DESIGN REVIEW BOARD JULY 21, 2017

DESIGN REVIEW BOARD SUMMARY

JUNE 16, 2017

The Jones House
50 South Main Street

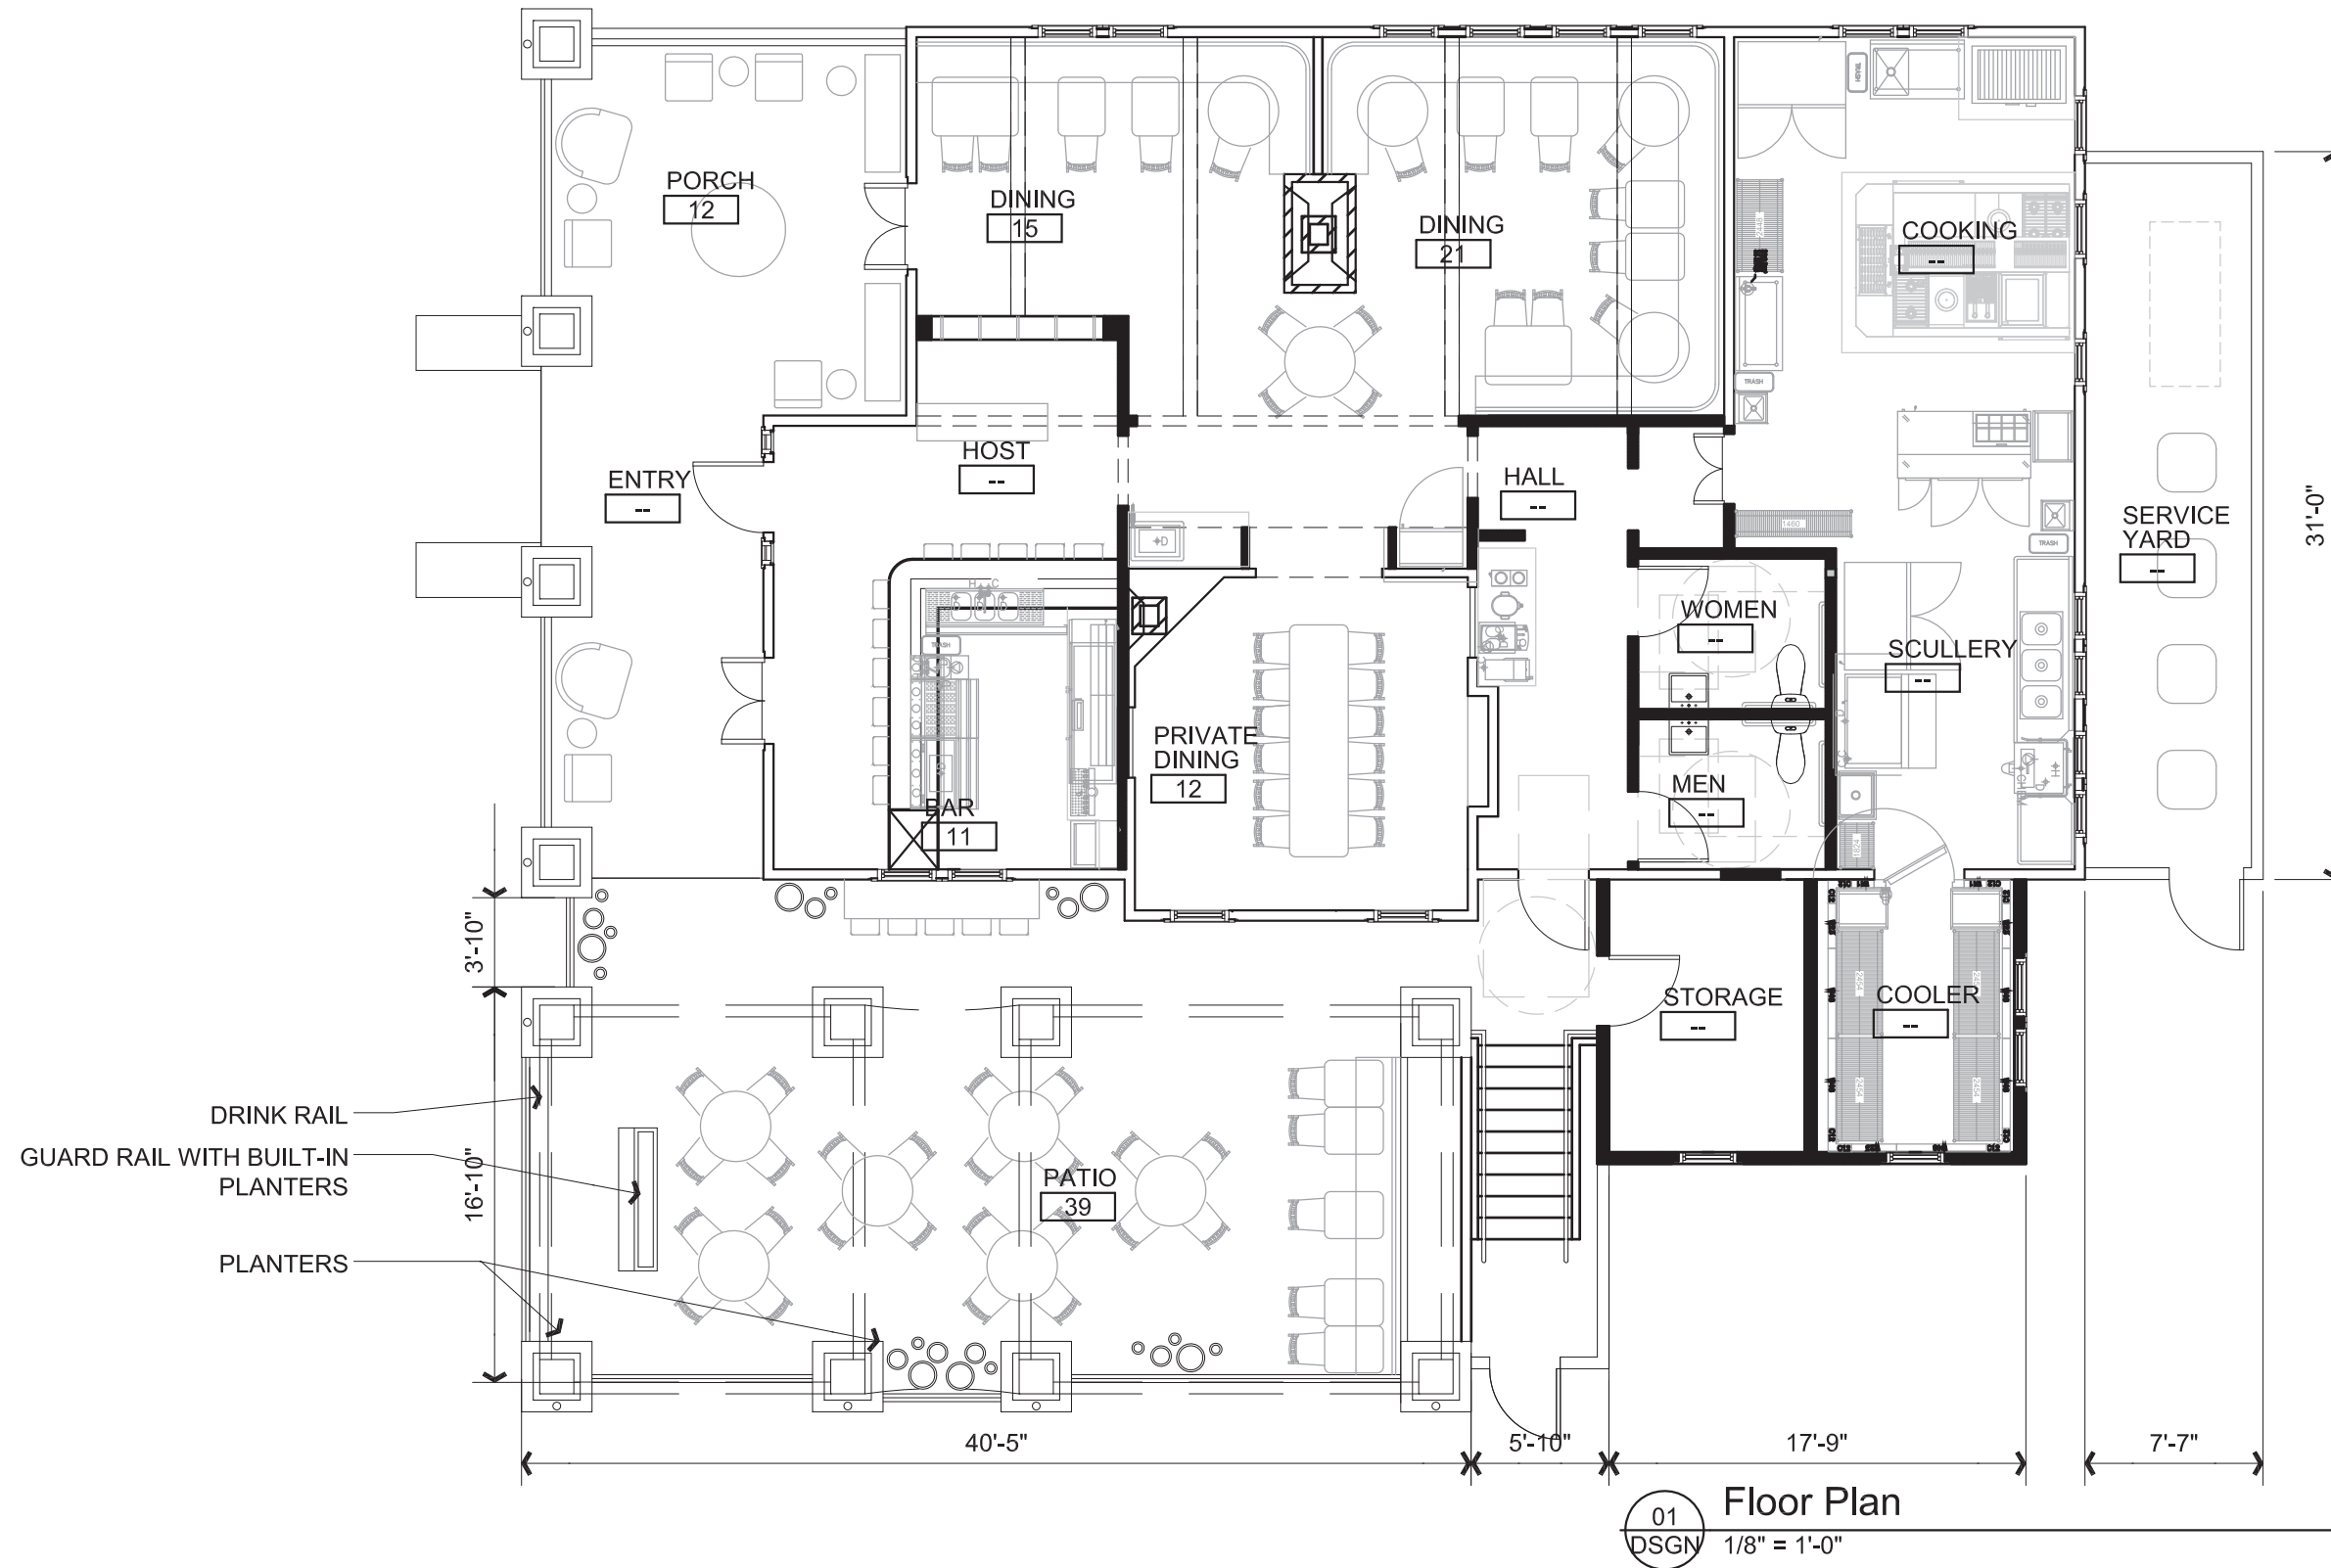
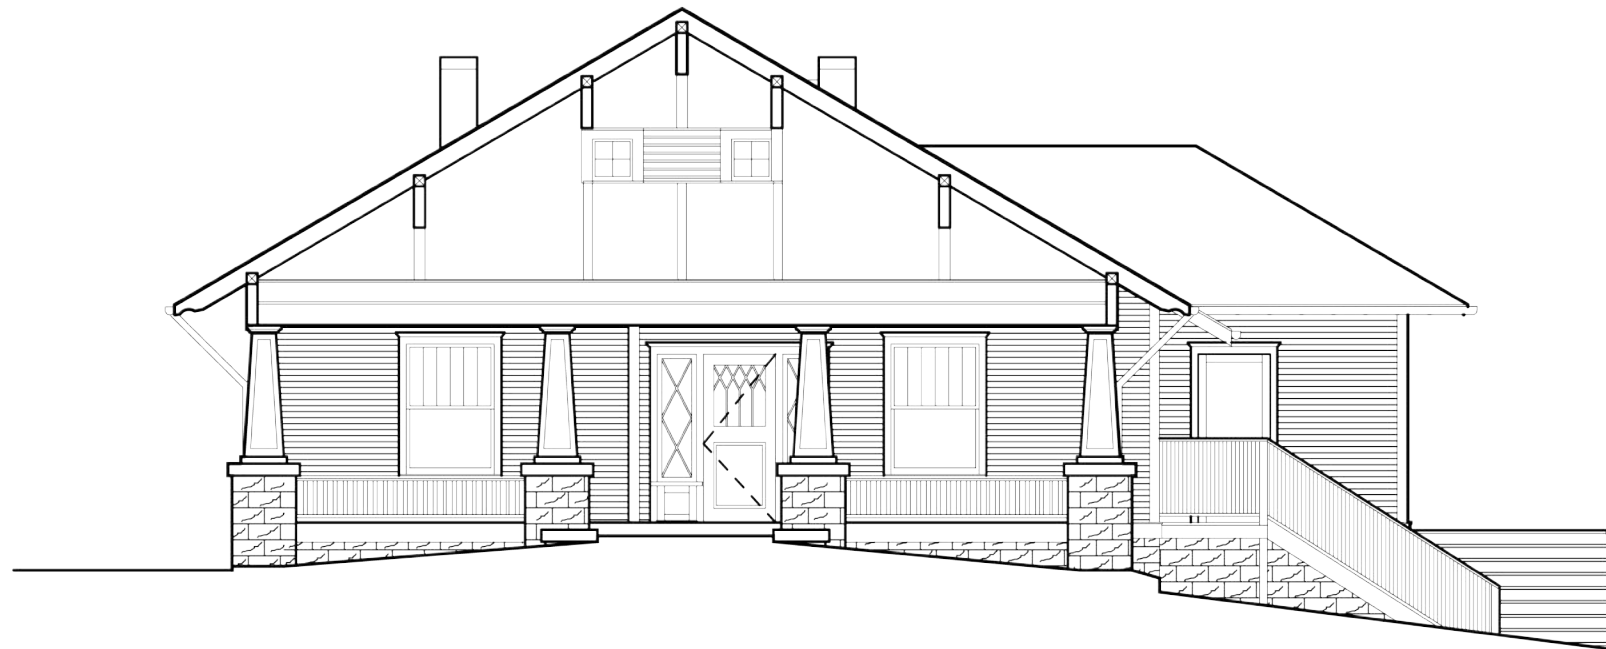
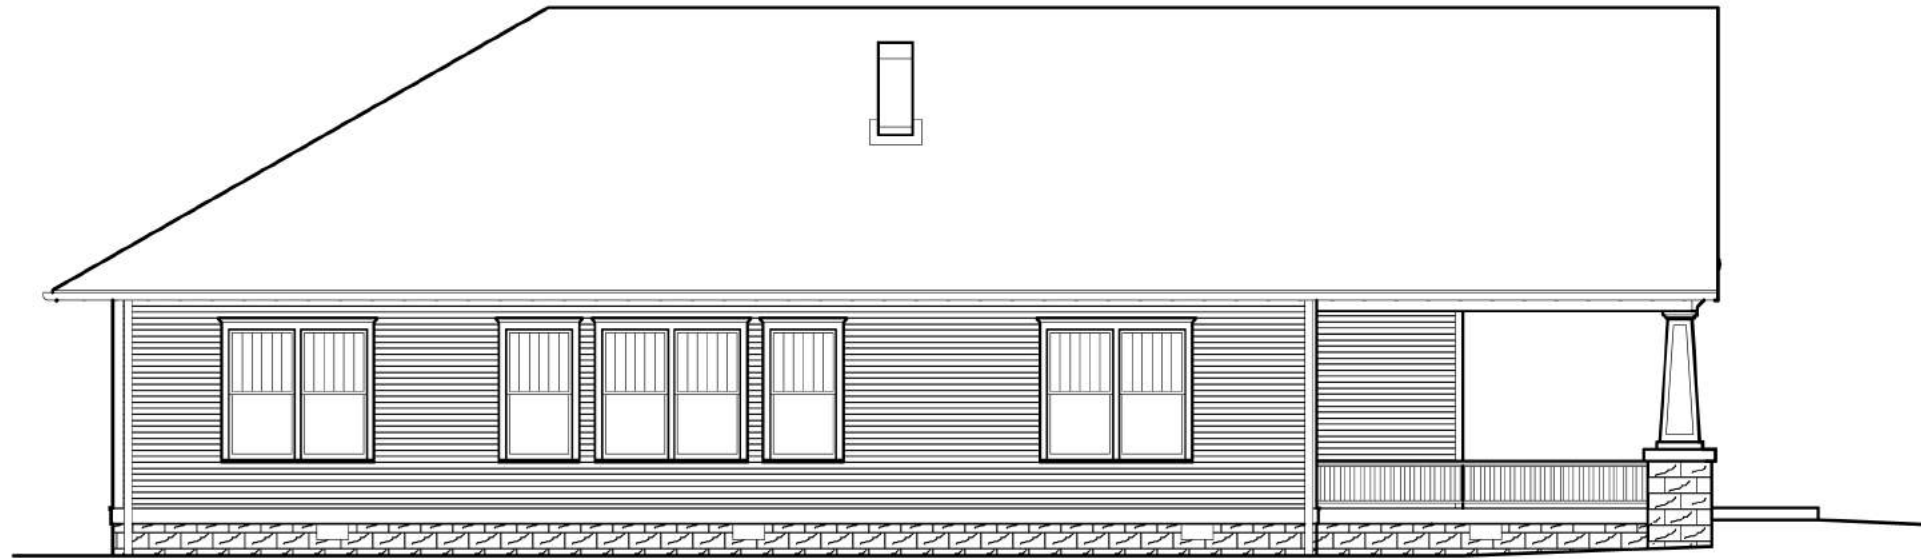
- Applicant will try to keep railing in the front and front door will be a single door with two sidelights.
- Historically the house had" those stacked stones and you saw and walked right up under the house." It was up on stilts.
